RECOMMENDED SERVICE BULLETIN NO. DAC1-25-01 REV. 6 SUPERSEDES DAC1-25-01 REV. 5

Type: DA 20-C1

EBC502 to Artex ELT upgrade.

Figure 1. Location of the ELT bracket assembly.

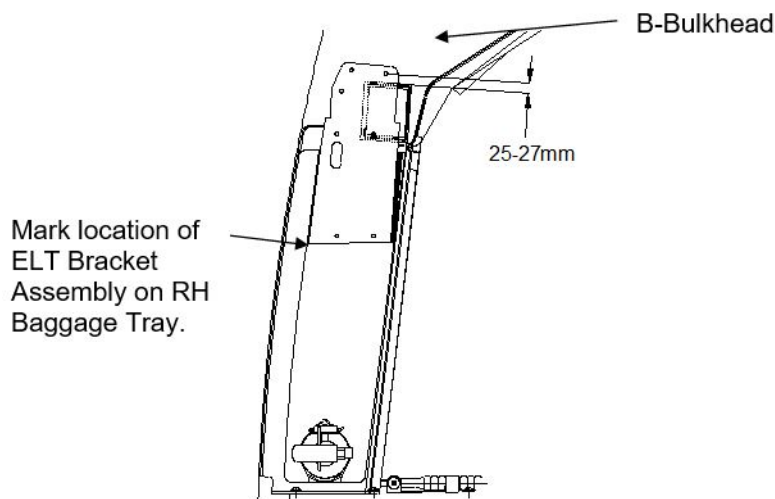
1. Remove the baggage center floor. Refer to AMM Section 25-10.
2. Ensure the ELT switch is in the OFF position.
3. Remove the existing EBC502 ELT and ELT tray.
4. Place the ELT bracket assembly (item 1) into the RH baggage tray, and position it so that the bracket assembly mounting holes are 25 mm to 27 mm aft of the existing ELT pocket. Mark the bracket location on the baggage tray. Refer to Figure 1.

Figure 2. Bonding surface.

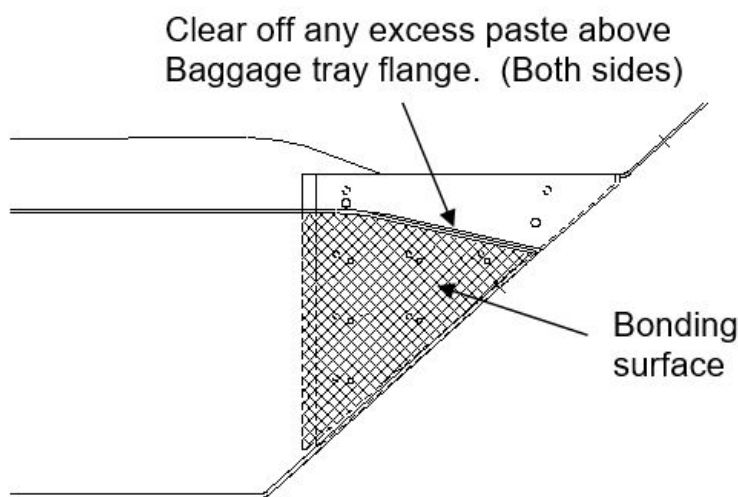
11. Apply the mixed resin to all bonding surfaces. Refer to Figure 2.

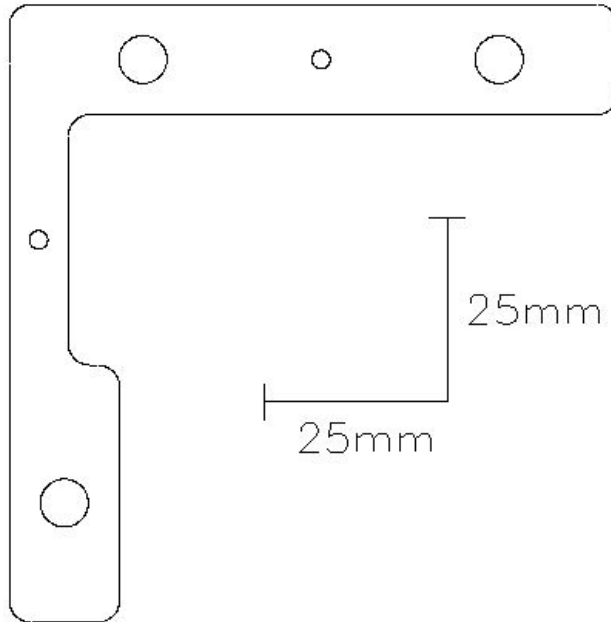
12. Apply mixed paste adhesive to the outer sides of the bracket assembly, and install the bracket into the baggage tray. Align the rivet holes, and use Cleco temporary fasteners to hold the bracket in place until the paste is cured.

Figure 3. Splices on the interface module.

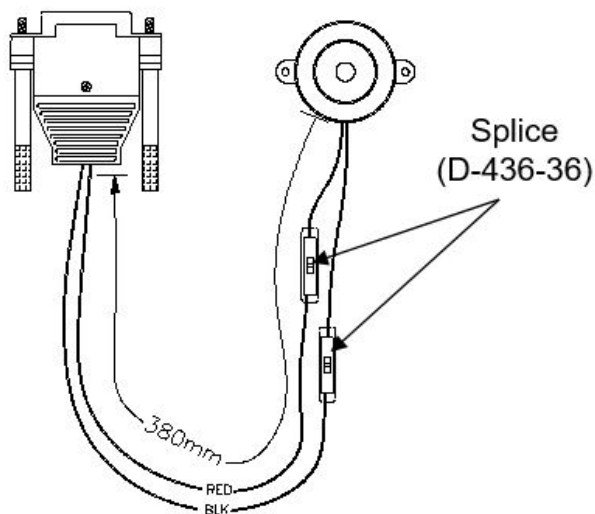
18. Install the plate assembly (item 3) behind the B-bulkhead. Secure the plate assembly using two rivets (item 17).
19. Splice the Artex ELT installation kit connector (item 9) to the Artex ELT buzzer (item 7) using the splices provided (item 13). Refer to Figure 3.

- A. Connect the red wire of the piezo to pin 8 of the 15-pin D-sub connector.
- B. Connect the black wire of the piezo to pin 7 of the 15-pin D-sub connector.
- C. Fabricate a short jumper wire (G-switch loop) of approximately 1.5 in. (38 mm) long.

- a) Strip approximately 0.15 in. (3 mm) of insulation from both ends of each of the wire.
- b) Dress and tin the bare wire ends to prevent the strands from fraying during terminal crimping operations.
- c) Solder the jumper wire to D-Sub pins 5 and 12.

Figure 4. Installation of coax, interface module, and buzzer.

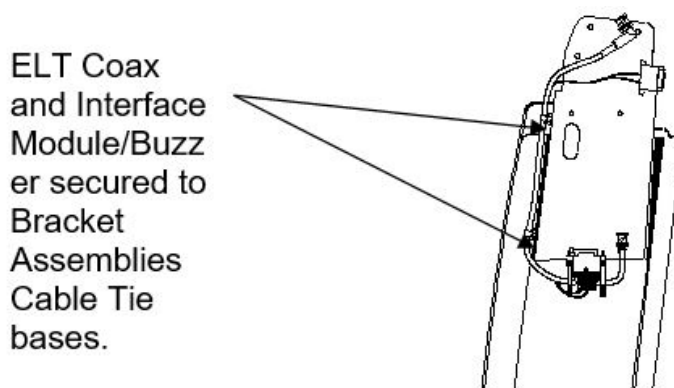
- 20. Route and secure the ELT coax assembly and interface module/buzzer on to the baggage/bracket tray's cable tie bases. Refer to Figure 4.

Figure 5. Installation of baggage/bracket tray. Coax and interface module/buzzer not shown.

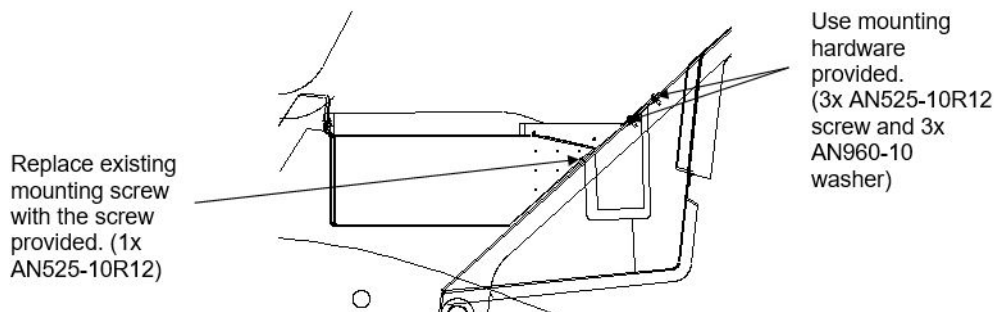
21. Install the baggage/bracket tray. Refer to Figure 5.

Figure 6. Installation of side bracket and ELT placard.

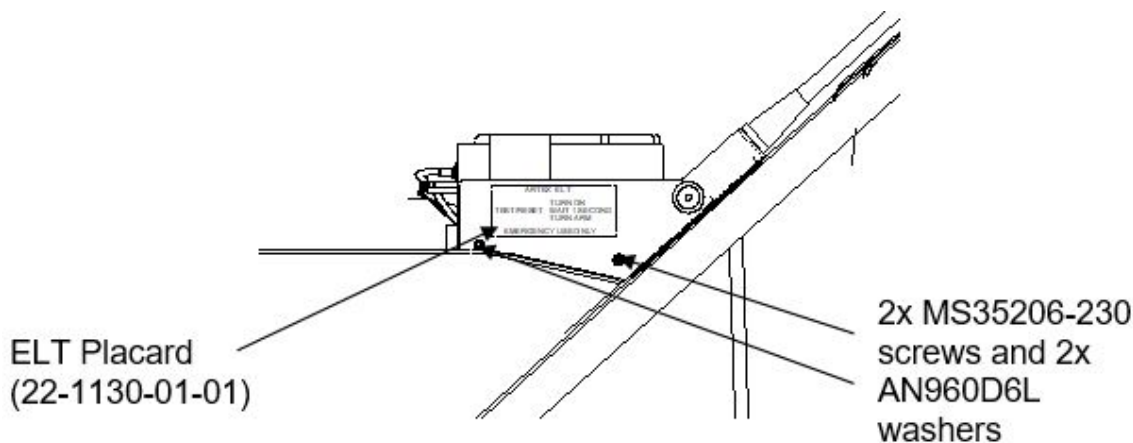
22. Install the Artex ELT tray (item 6 or 6a) using four screws and four washers (items 11 and 12).
23. Install the ELT unit (item 5 or 5a).
24. Install the ELT side bracket (item 2) onto the ELT bracket assembly using two screws and two washers (items 11 and 12). Refer to Figure 6.
25. Install the buzzer into the side bracket hole using the provided plastic bezel nut in accordance with the Artex ME406 or Artex ELT1000 manual. Refer to Figure 7.
26. Install the antenna into the side bracket hole in accordance with the Artex ME406 or Artex ELT1000 manual. Attach the ELT coax to the ELT antenna. Refer to Figure 7.
27. Install the ELT placard (item 10) onto the ELT side bracket. Refer to Figure 6.
28. Install the baggage center panel. Refer to AMM Section 25-10.
